<b>Project title</b>	RFD 2022 Major Flood Model Update Stanley River and Neurum Creek (SRN) Catchment
<b>Job number</b>	305456-00
<b>File reference</b>	Peer Review Technical Note
<b>cc</b>	Alana Mosely
<b>Prepared by</b>	Greg Rogencamp, Kok Keng Tan
<b>Date</b>	3 February 2025
<b>Subject</b>	Independent Technical Review – Technical Note

Subject Flood Model Review Checklist

<b>Project Name</b>	RFD 2022 Major Flood Model Update Stanley River and Neurum Creek (SRN) Catchment	<b>Date</b>	13/1/2025
		<b>Version</b>	2

### APPENIDX A

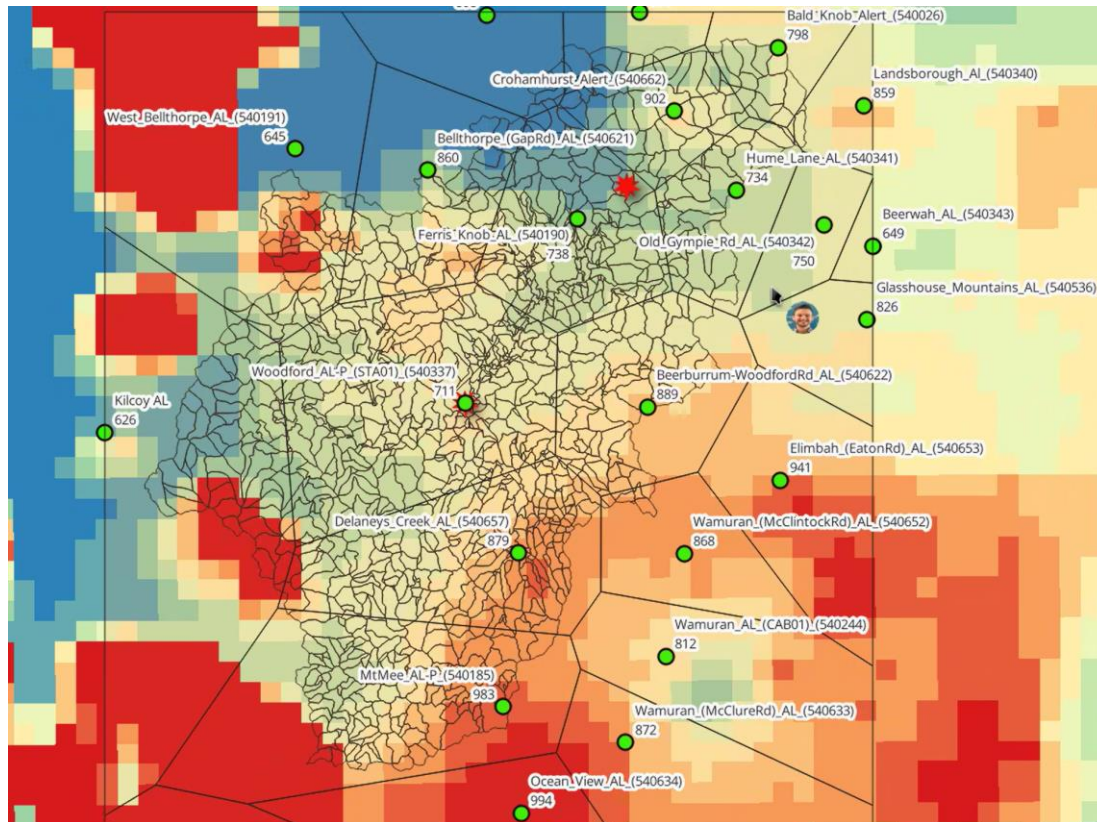
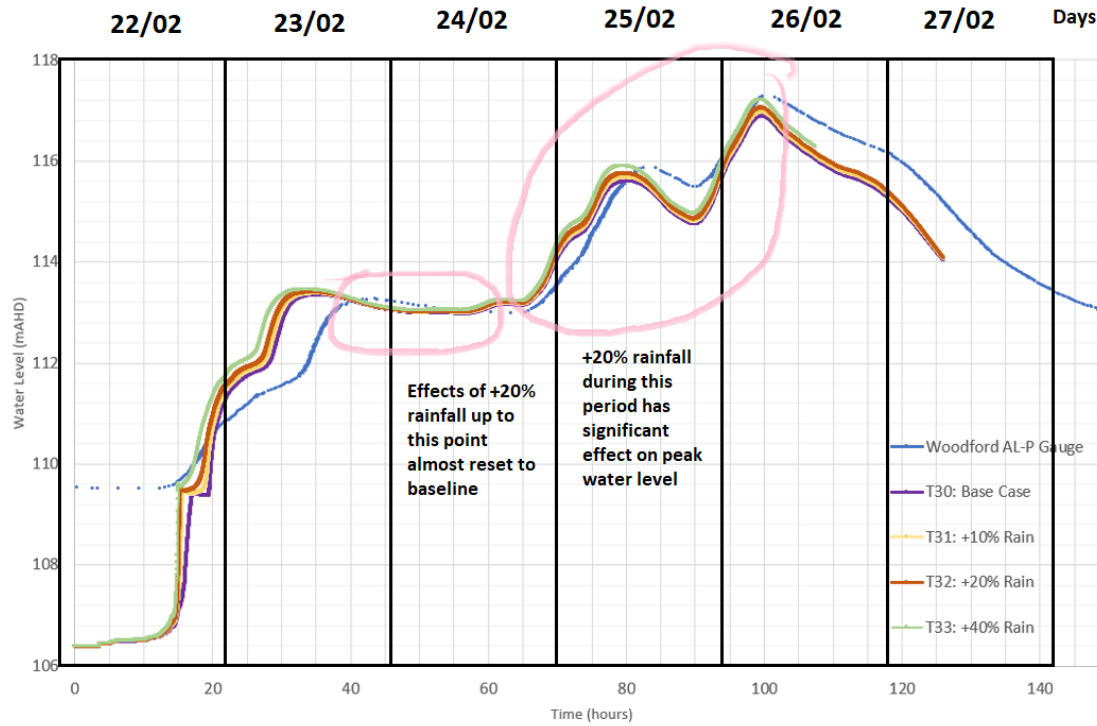
Check Item	Reviewer Comments (Arup)	Designer Response (CMB)	Rank	Reviewer Closeout
	<p>Woodford Gauge requires a manual rainfall uplift to achieve a better match on peak flood level. The radar image in Appendix A indicates that high-intensity rainfall did occur over the mid-catchment region. This suggests that the current mid-catchment rainfall gauge network is insufficient to adequately capture rainfall variation. Overall, given the available data and approach, it is considered that the standard model parameters relevant for subsequent design event runs have been appropriately calibrated and the performance is unlikely able to be improved further. Based on the information presented, it is deemed that sufficient research and testing have been conducted and approach taken is in line with best practice. This comment is now closed.</p>	<p>recorded peak. Results of this test are shown in APPENDIX B of this document. A 20% increase in rainfall was then tested which produced good correlation to gauge levels. It was believed this was a more reasonable approach to calibration than further increases to roughness values.</p> <p>Note - the May 2015 event applied parameters from the February 2022 event, including the rainfall increase, without initially testing model results without the rainfall increase. As May 2015 was a validation event only, no update is proposed at this stage.</p> <p><b>Query 3:</b> Similar to the test discussed above, a sensitivity has been undertaken, using the final TUFLOW model and removing the 20% increase to rainfall for the January 2011 event, to see how the outcome would differ. Result figures are also shown in APPENDIX B. The following was noted:</p> <ul style="list-style-type: none"><li>• Peak water level reduced at the Woodford gauge by approximately 310mm compared to the original validation results. The overall shape remained fairly similar to original results - the main difference is at the event peak.</li></ul>

The first image below is a total of the radar rainfall over the February 2022 event. It could be identified that the West Bellthorpe Alert rainfall gauge appears to underestimate the rainfall experienced for the subcatchments informed by this gauge. However, for other areas the analysis is somewhat inconclusive. The radar north of Bellthorpe Alert appears somewhat suspect, but if taken to be true, indicates that the area of higher rainfall between Bellthorpe AL, Ferris Knob AL and Woodford AL could be underestimated by the recorded gauge levels.

This is emphasised if focused on the total rainfall radar for one main part of the event. The calibration results indicate the effect of the 20% rainfall increase is negligible prior to 25/2/2022; the results do indicate influence on peak results for the 25/2/2022 (see below hydrograph). Looking at the radar for the 25/2/22 (third image below), a higher area of rainfall is seen to occur in-between the Bellthorpe, Ferris Knob and Woodford AL gauges.

Graph for Query 2 - January 2011 - Calibration Phase Model - Sensitivity Test  
No Rainfall Increase Scenario (T36) vs 20% Rainfall Increase Scenario (T40) vs Gauge Level

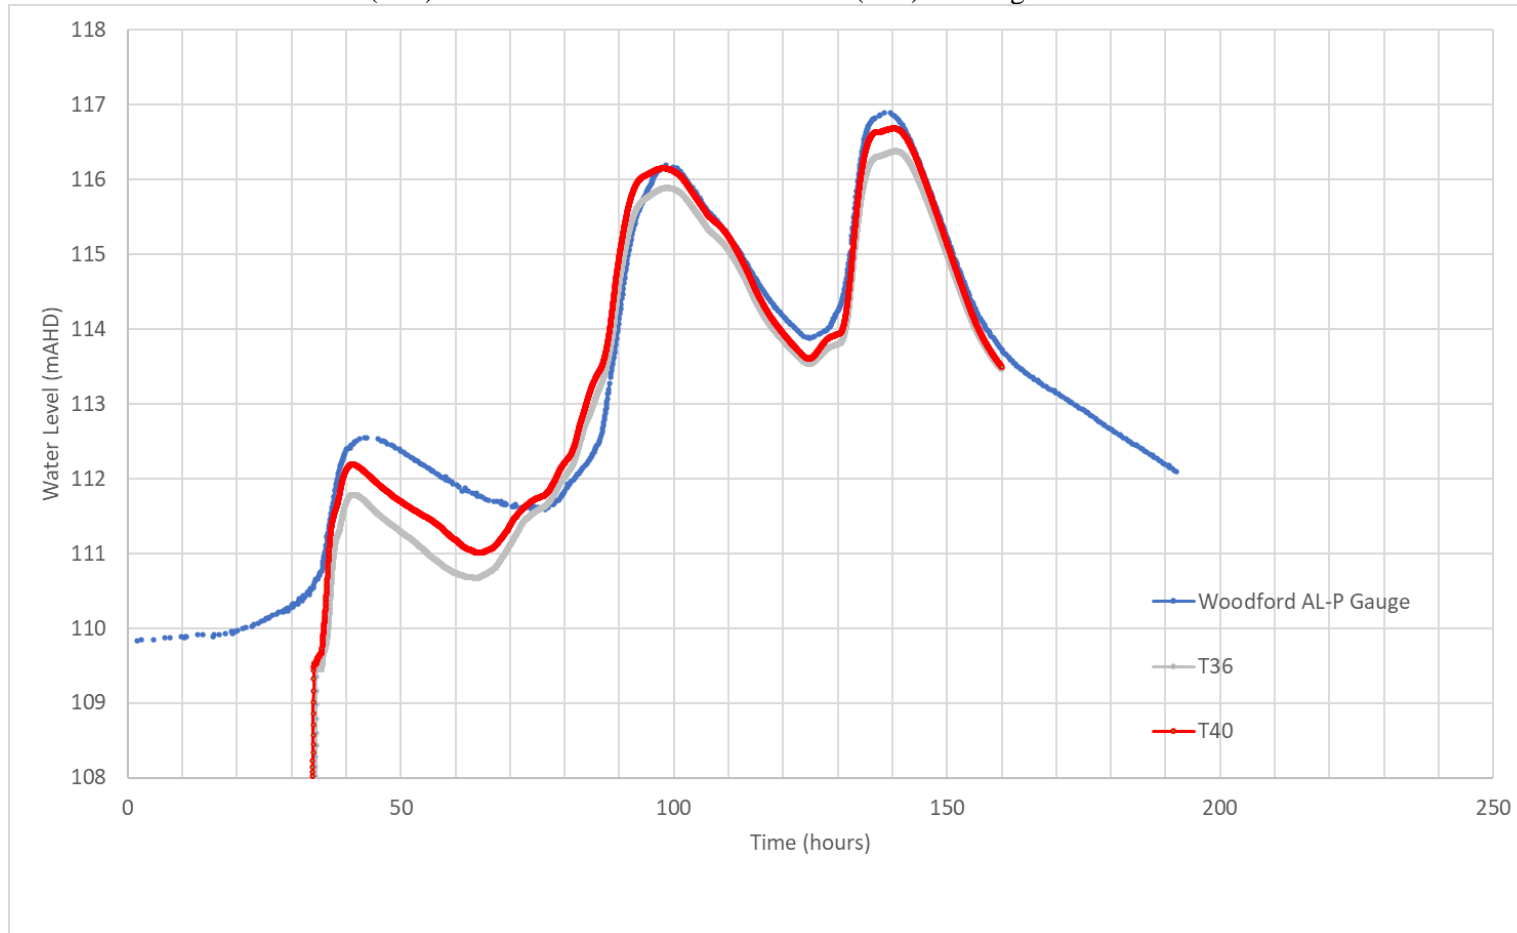
Check Item	Reviewer Comments (Arup)	Designer Response (CMB)	Rank	Reviewer Closeout
		<ul style="list-style-type: none"> <li>• Peachester gauge demonstrates minor peak water level reductions of approximately 80mm.</li> <li>• In general, the largest water level reductions were at Woodford and the surrounding catchments.</li> </ul>		
Peak and volume of flow hydrograph match	<p>The WBNM model was jointly calibrated with TUFLOW to flood level hydrographs at two gauge locations along Stanley River (Woodford and Peachester).</p> <p>The timing, pattern and peak flood levels across all three (3) events are reasonably well matched to those recorded.</p> <p>Validation against the flood marks data, on the other hand, showed mixed results. There is likely some limitations around the reliability of flood mark data. Accordingly, it may be more prudent to place greater weight on the performance at the stream gauge.</p> <p>13/1/25: Response noted.</p>	<p>This statement aligns with adopted approach; focus was placed on alignment with gauge recorded results primarily, with flood mark results subsequently reviewed.</p>	<p>Commentary No action</p>	Closed

## APPENDIX C

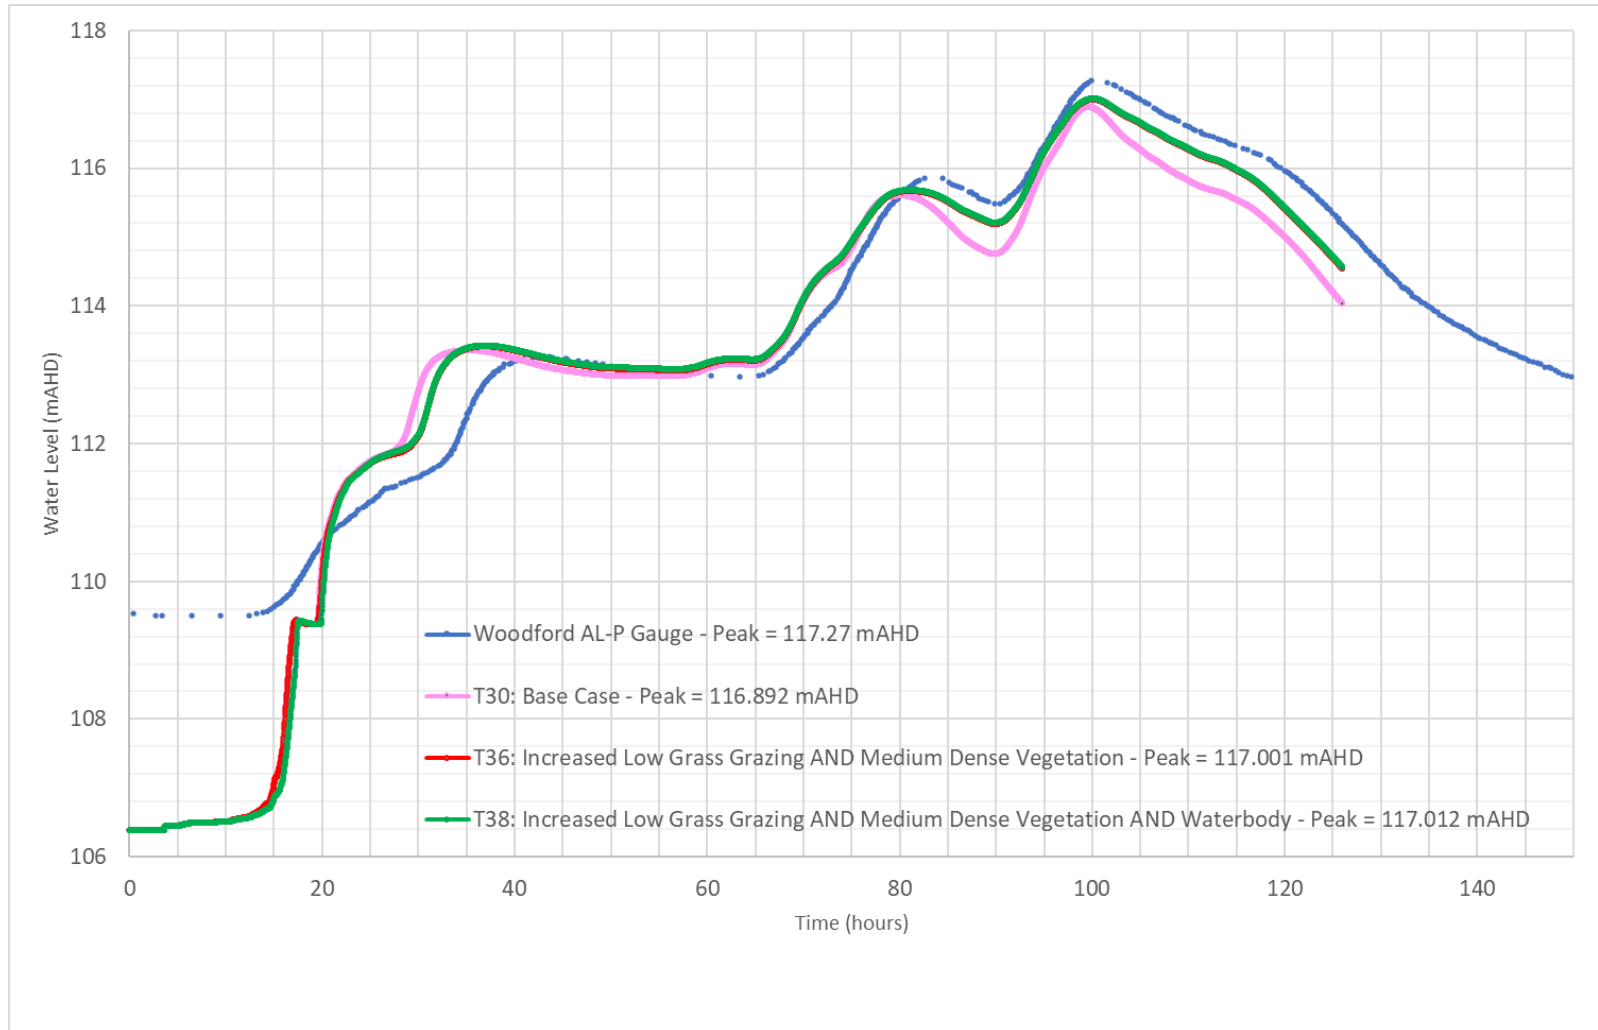
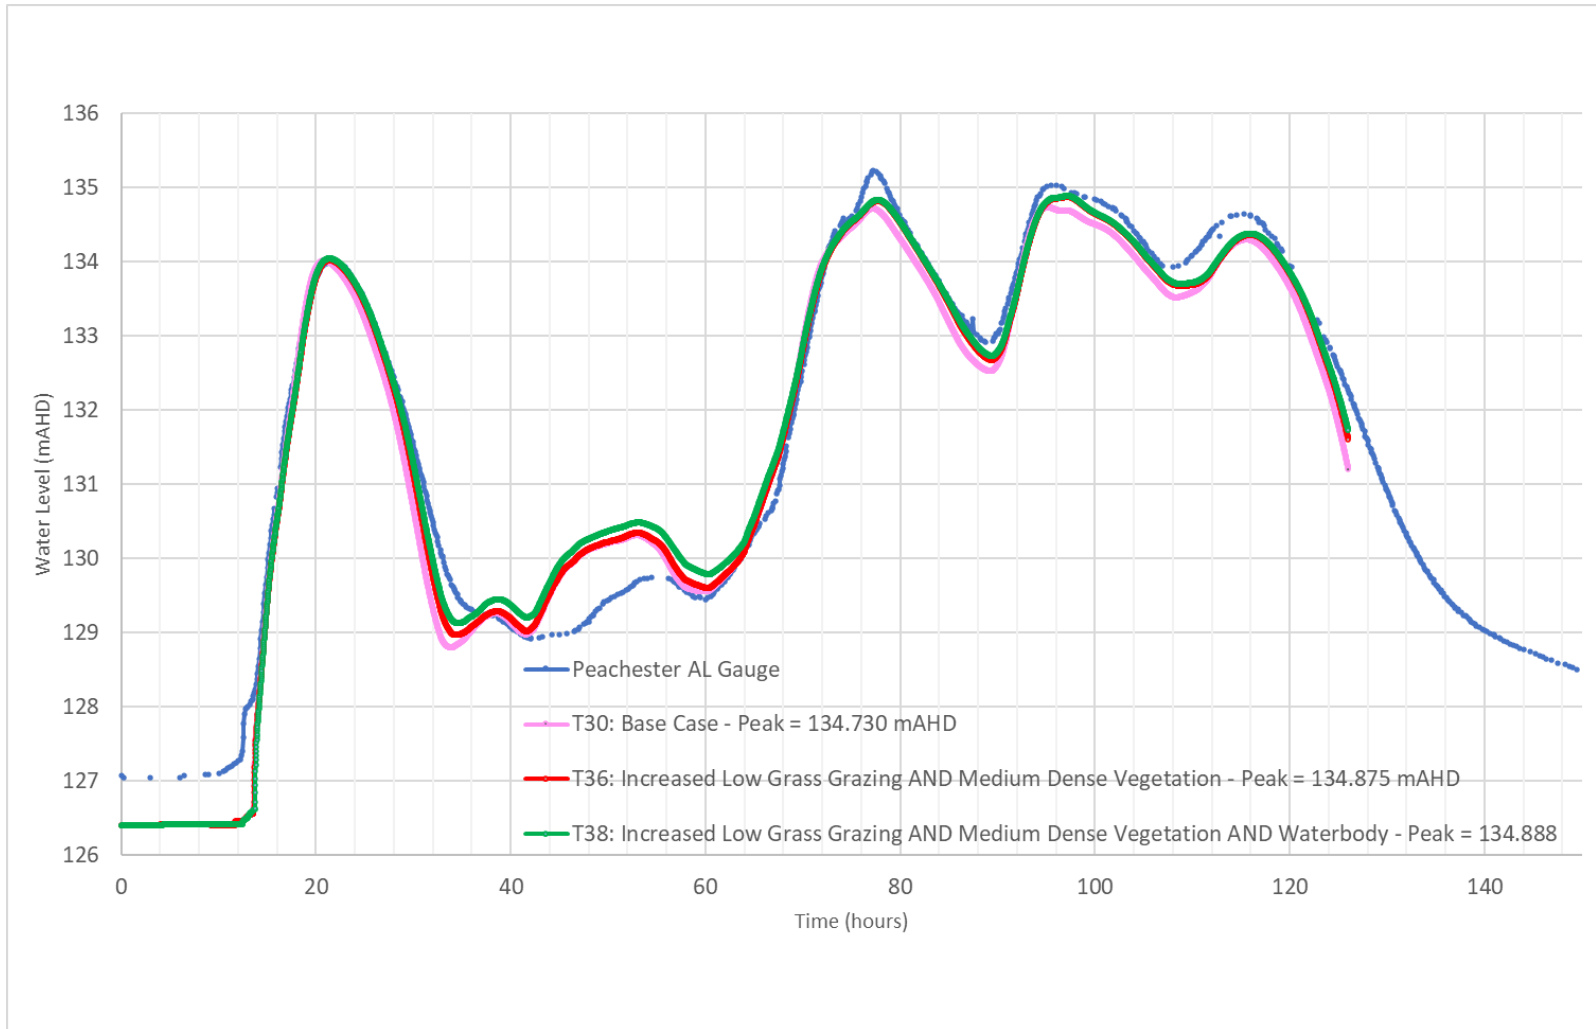
Check Item	Reviewer Comments (Arup)	Designer Response (CMB)	Rank	Reviewer Closeout
	<p>In reviewing the 'Z0' grid, most of the high intensity flow leading towards the gauge locations occurs within the channels covered by 'Waterbody', which is defined as 0.03. As these are highly vegetated mountainous streams, a higher Manning's n value could be justified.</p> <p><b>Has any further effort been expended to review the roughness values of the streams (i.e. adopt a higher Manning's n for 'Waterbody' to improve the calibration results)?</b></p> <p>Of note, the continuing loss values applied for calibration events (1mm/hr) are lower than ARR Data Hub losses. Application of lower continuing loss, in effect, also increases the rainfall depths being applied. It may be worthwhile to sensitivity check the calibration event performance when standard design losses (2.1mm/hr) are adopted.</p> <p>13/1/25: Responses noted. Comment closed.</p>	<p>Noted that lowering continuing loss values essentially increases rainfall depth. The chosen value was an outcome of calibration and was only used during calibration runs (ARR Data Hub values used for design event runs). In the initial part of calibration modelling (Feb 2022), a test was undertaken comparing use of 0mm/hr and 2.5mm/hr continuing loss. Results of this test are shown in APPENDIX D. This test indicated dropping the continuing loss value from 2.5 to 0mm/hr increased peak water levels by 300-400mm at the Woodford gauge (noting that this was an earlier build of the model). This was a significant outcome as the model was underpredicting water levels. As a zero continuing loss value is unrealistic, a 1mm/hr continuing loss value was adopted to support better model calibration. It is noted some other RFD catchments also utilise continuing loss values of 1mm/hr in calibration events - lower than ARR Data Hub values.</p> <p>However, it is identified that the February 2022 and January 2011 events were multi-day flood events. It is possible that over such a long duration, continuing loss could reduce through the event as the catchment becomes more saturated and infiltration reduces. This may justify the use of a lower continuing loss value as compared to design event simulations,</p>

A test was undertaken during SRN calibration, which increased the waterbody Manning's (TMF ID =15) from 0.03 to 0.04.

- Apart from minor differences at lower levels, the T36 and T38 scenarios are very similar. Minor differences at Peachester at lower levels (~130 mAHD) are potentially because flows are contained in channels (hence spatially coinciding with area designated as Waterbody Manning's n roughness value).
- There are only minor differences in peak water levels of 11mm and 13mm at Woodford and Peachester gauges as a result of increasing waterbody Manning's n value.

As such, during calibration it was concluded that it was not beneficial to increase the waterbody Manning's n value, as it did not significantly increase peak water levels at the gauges.

2.5mm/hr CL (T15) vs 0mm CL (T19) vs Gauge Level (Woodford AL-P)

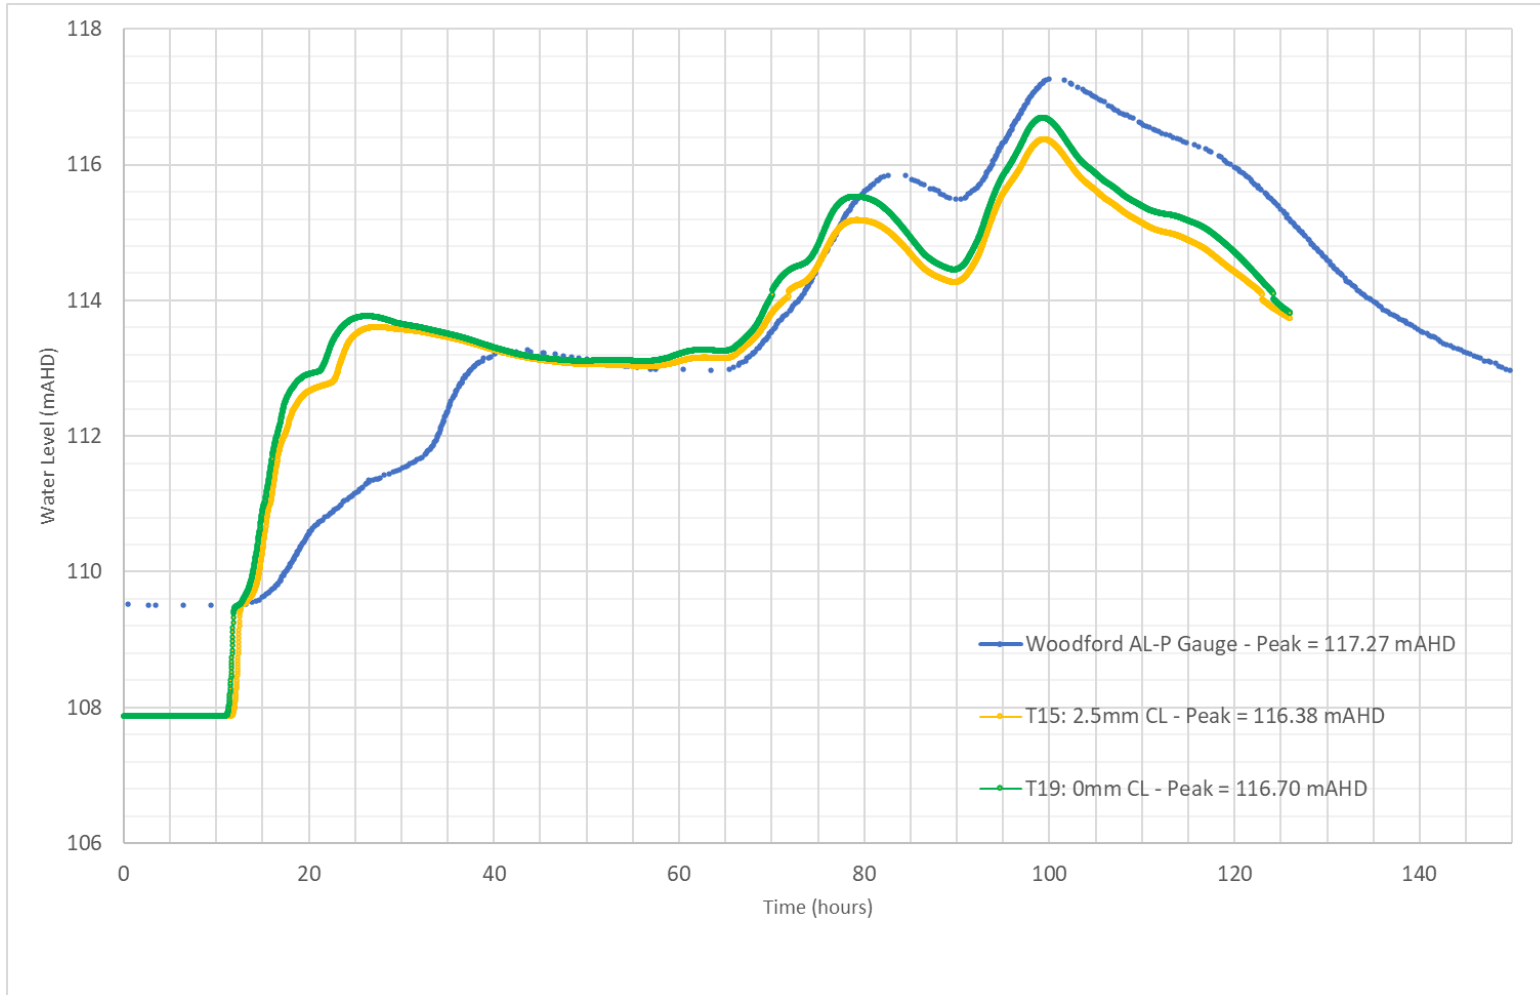
Check Item	Reviewer Comments (Arup)	Designer Response (CMB)	Rank	Reviewer Closeout
		<p>which for this catchment occur over a shorter duration. Some commentary on reduced CL for long events can be found in ARR19 (see Section 3.7.2) which may be relevant in this scenario.</p> <p>As such, ultimately ARR Data Hub loss values were adopted for design event runs.</p>
